This addendum (109 pages) shall form a part of and be included in the Contract Documents for the above titled project and no consideration will be entertained for extras to the Contract due to failure of the contractor to become thoroughly familiar with this addendum.

<b>Project:</b>	Provincial Fire Life Safety – Lynn Lake, Gillam, and Thompson Sites	
<b>Commission Number:</b>	21569.44, 21569.49, 21569.50	SMS Project No.: 25-001-16
<b>Date:</b>	October 27, 2025	
<b>Pages:</b>	2 + 5 attachments

Project Title  
**PROVINCIAL FIRE AND LIFE SAFETY PROJECT - LYNN LAKE, GILLAM, AND THOMPSON SITES**

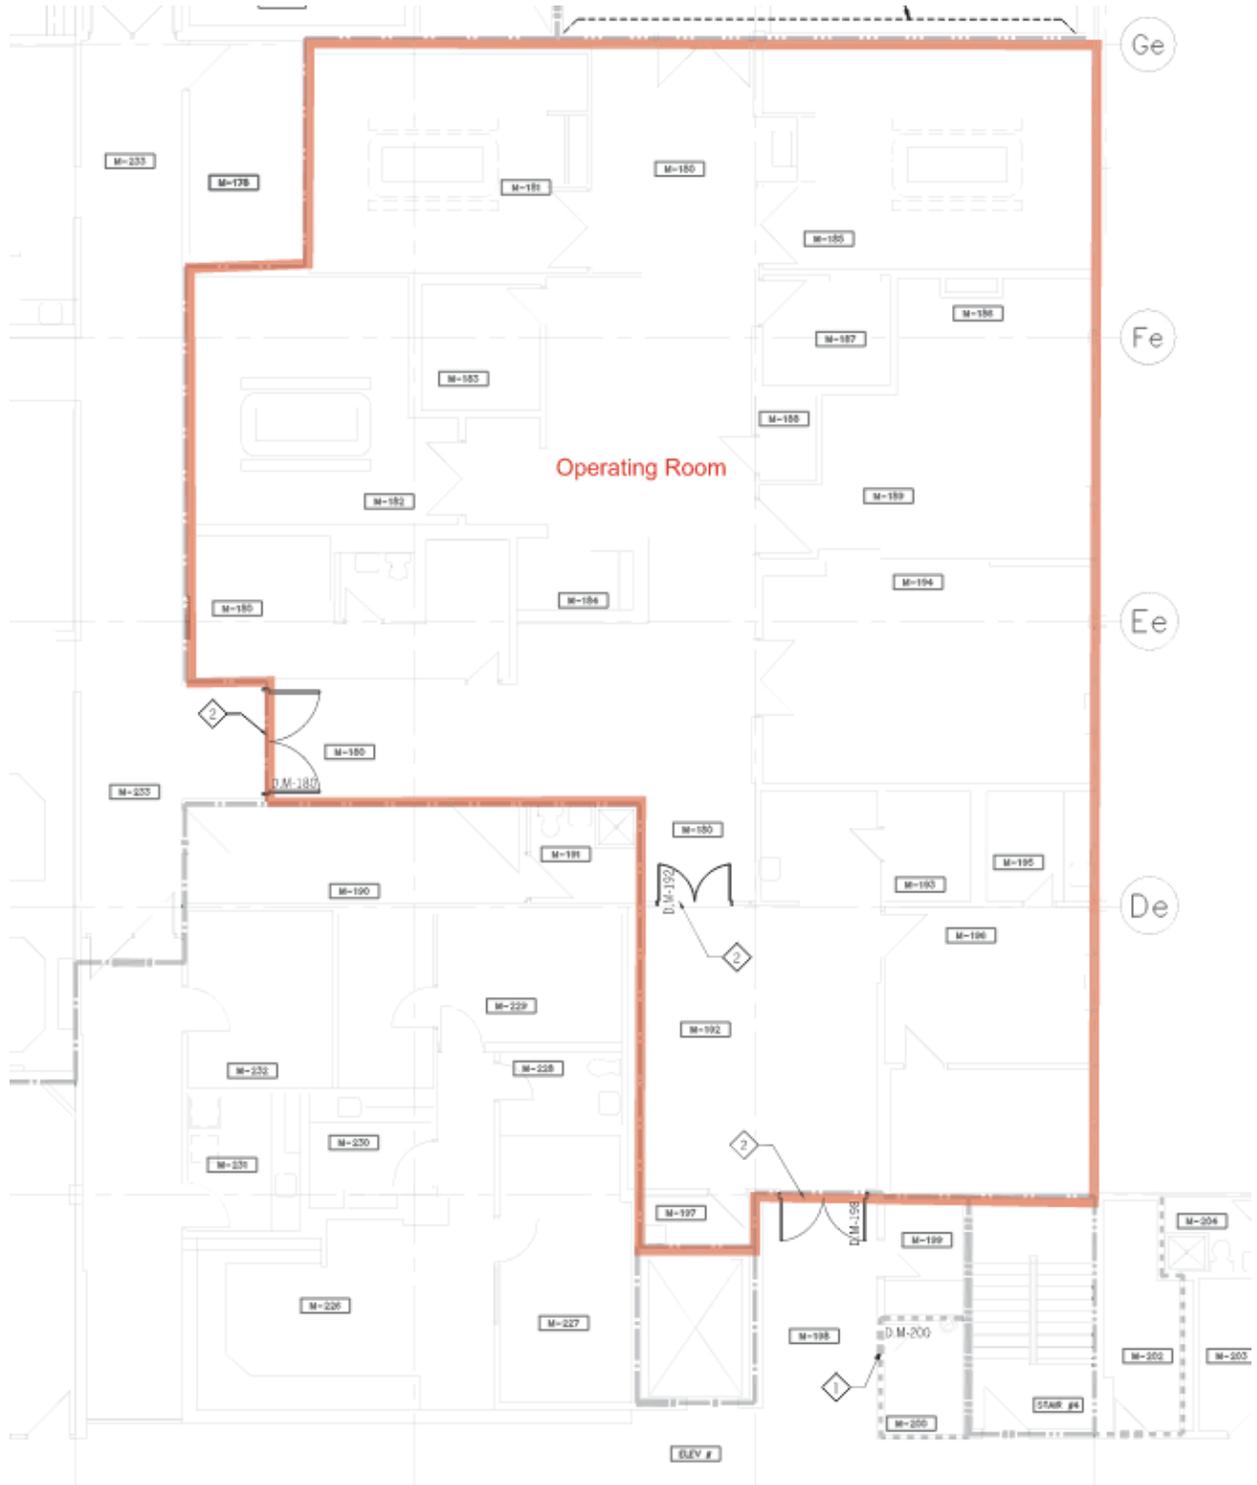
.6 Q: “[For Thompson General Hospital] are there any details available regarding the room used as areas of refuge?”

A: [ft3] [Please see following sketch showing areas] of refuge at Thompson General Hospital.

.8 Refer to drawing E2-001 Site Plan – Electrical

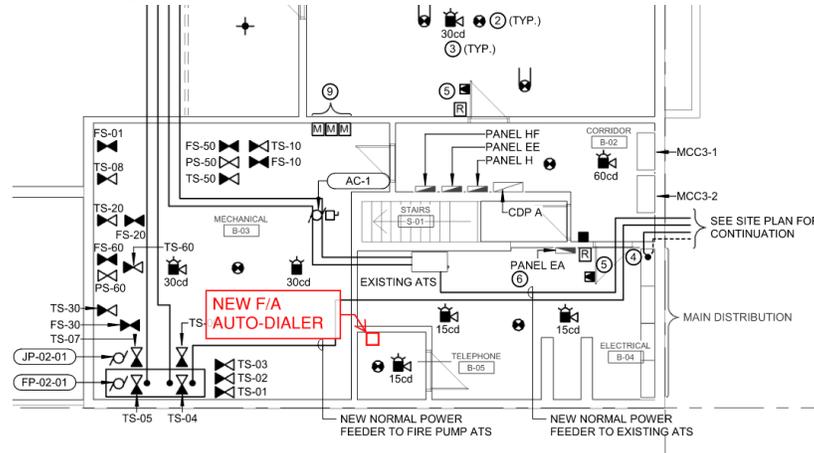
.1 Revise underground cabling to generator enclosure as below:

.9 Refer to drawing E2-211 Basement/Crawlspace Plan – Electrical – New Construction

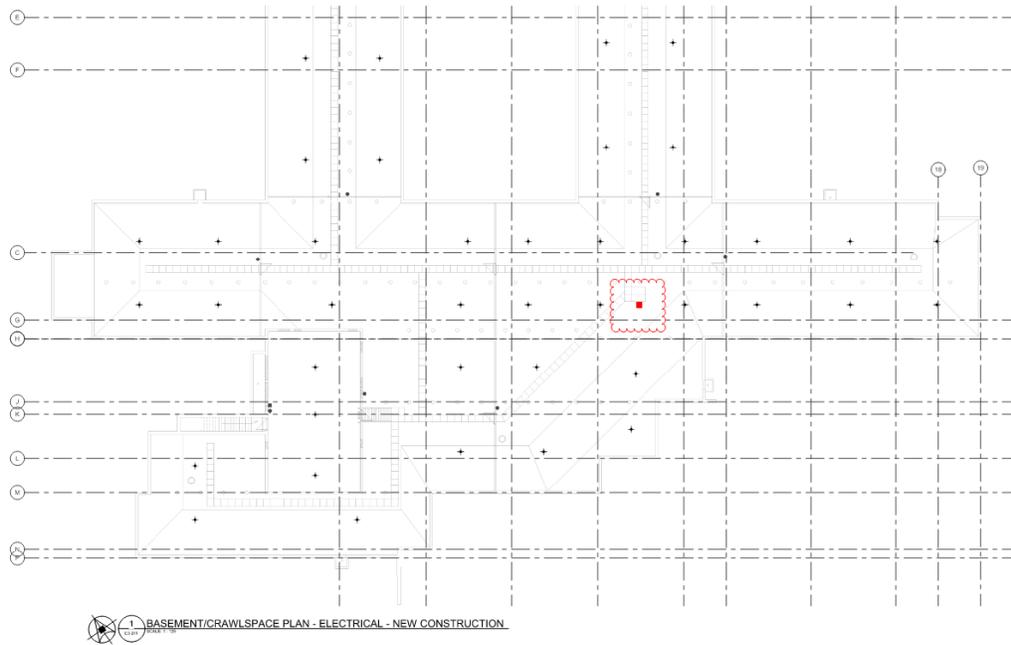
- .1 Provide new fire alarm auto-dialer in Telephone room B-05, refer to below sketch for approximate location:

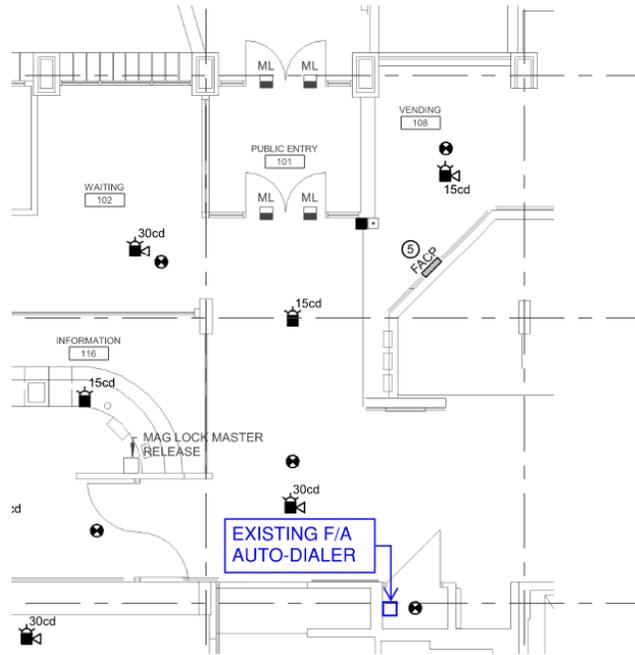
- .12 Refer to drawing E4-211 Ground Floor Plan – Block 1 – Fire Alarm – New Construction
  - .1 Replace drawing with re-issued drawing (enclosed).
- .13 Refer to drawing E4-221 First Floor Plan – Block 1 – Fire Alarm – New Construction
  - .1 Call up existing key note #6 at new annunciator in “Information”, room 116.
  - .2 Wire and connect existing fire alarm auto-dialer to new fire alarm system. Coordinate with monitoring agency for monitoring of trouble and alarm signals from new fire alarm system. Refer to below sketch for location of existing auto-dialer:

- .1 Refer to attached drawing G1-000 Phasing Plan for Lynn Lake Hospital.

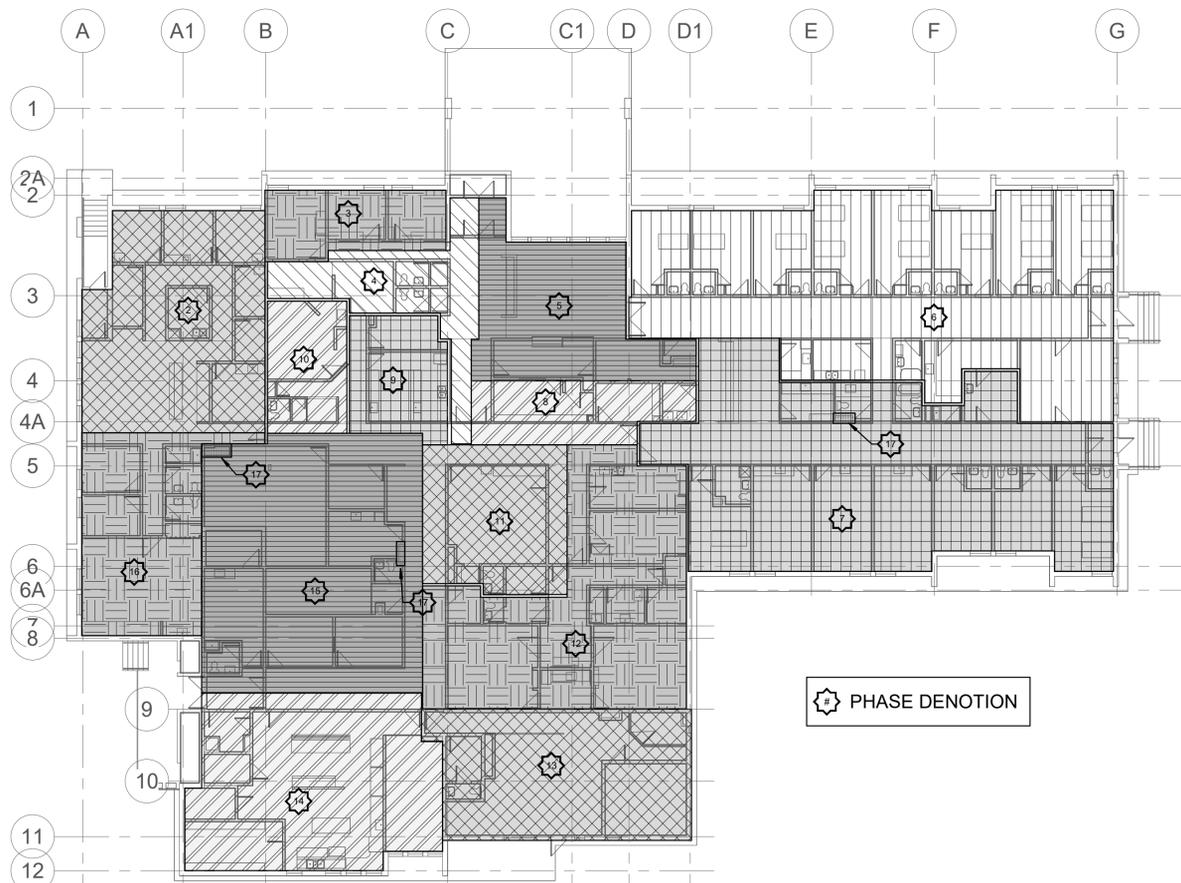
- .1 Add paragraph 1.5.8.1.3.3 to read as follows:
    - .3 New fire-rated wall partition and double door installed as shown on architectural drawings A3-211 to be completed in two separate phases to maintain access to Corridor 135 throughout construction.

- .2 Add paragraph 1.5.8.1.3.4 to read as follows:
    - .4 New fire-rated wall partition and double door installed as shown on architectural drawings A3-212 to be completed in two separate phases to maintain access to Corridor 146 throughout construction.

- .2 Refer to attached revised drawing M1-222 – Fire Pumphouse Plan & Details – Fire Protection – New Construction with clouded revisions.
    - .1 Location of tamper switches is clarified on domestic water fill line.

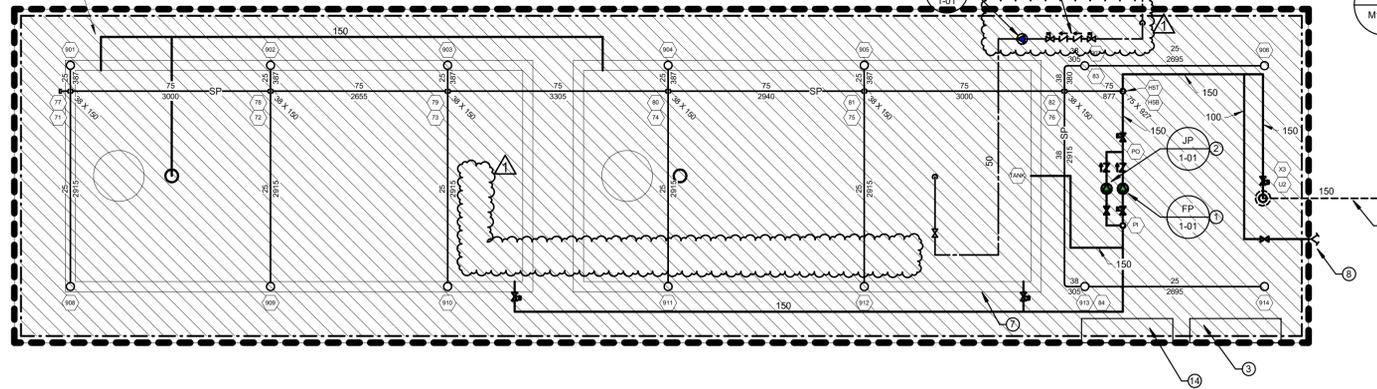
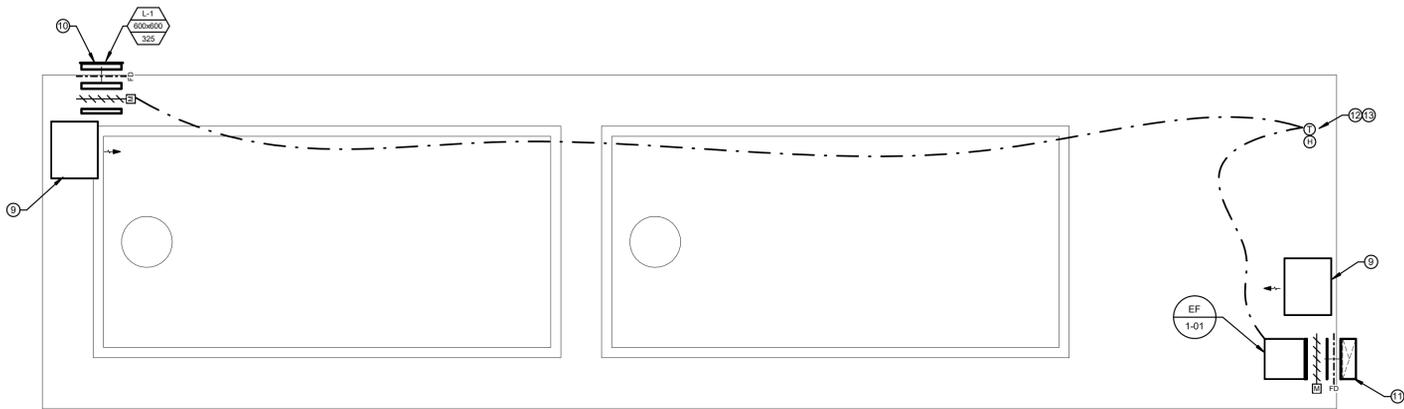
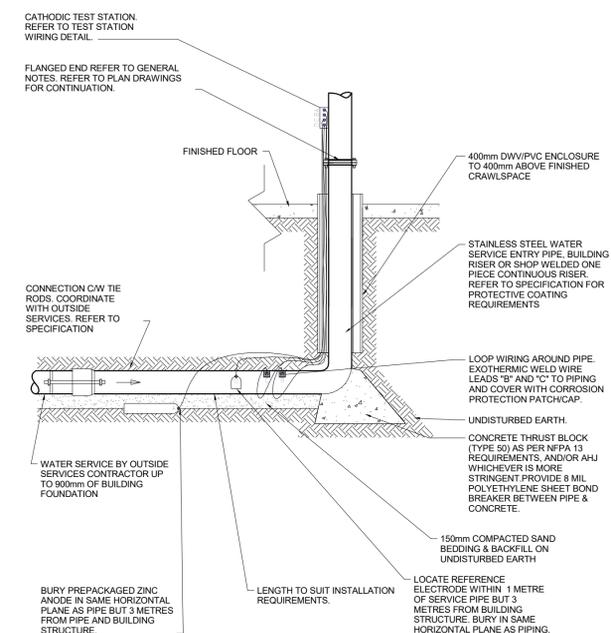
- .2 Extent of domestic water fill line is clarified.
  - .3 Refer to attached revised drawing M1-223 – Section & Schematics – Fire Protection – New Construction with clouded revisions.

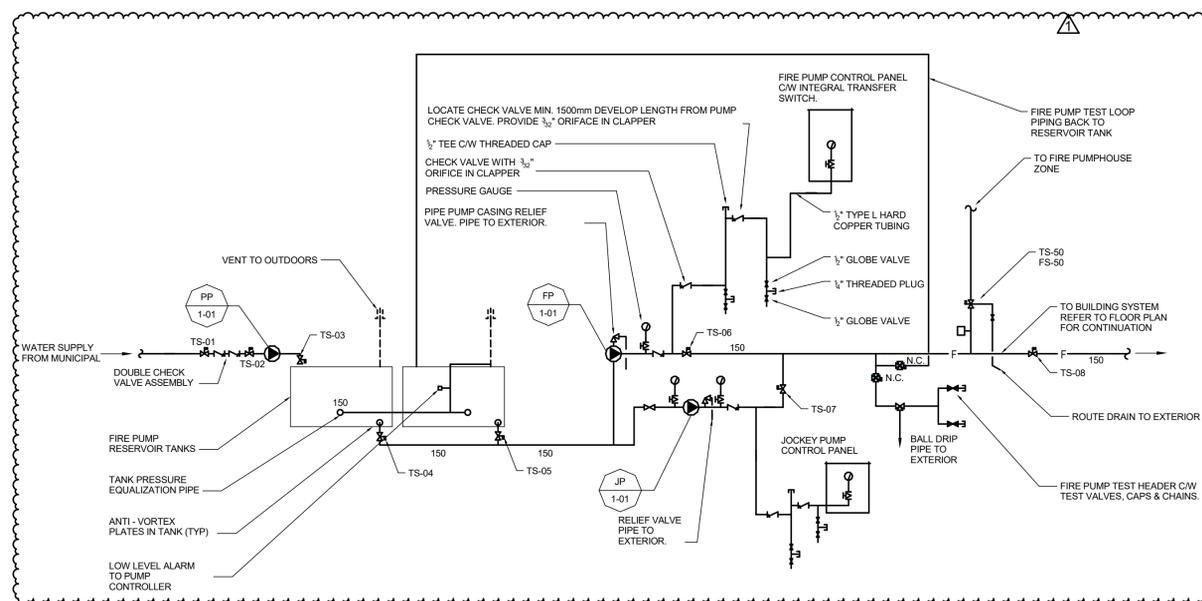
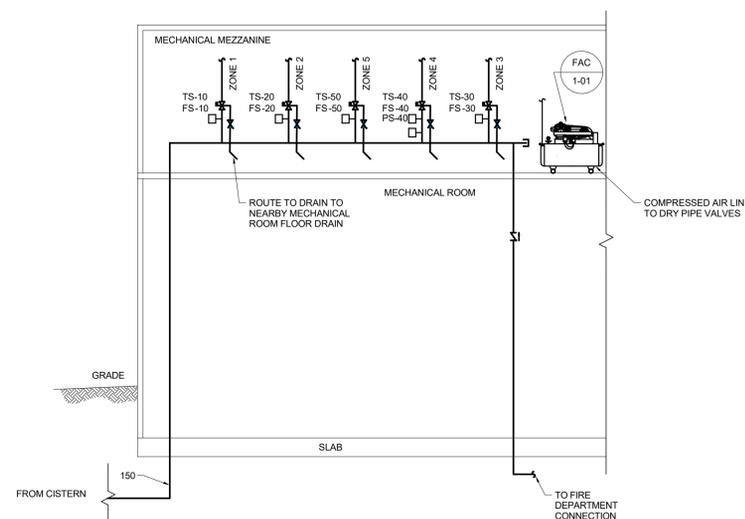
- .3 Reservoir tank venting
      - .4 Fire pump test loop piping
  - .4 Refer to drawing M2-211 – BASEMENT/CRAWLSPACE PLAN – FIRE PROTECTION – DEMOLITION
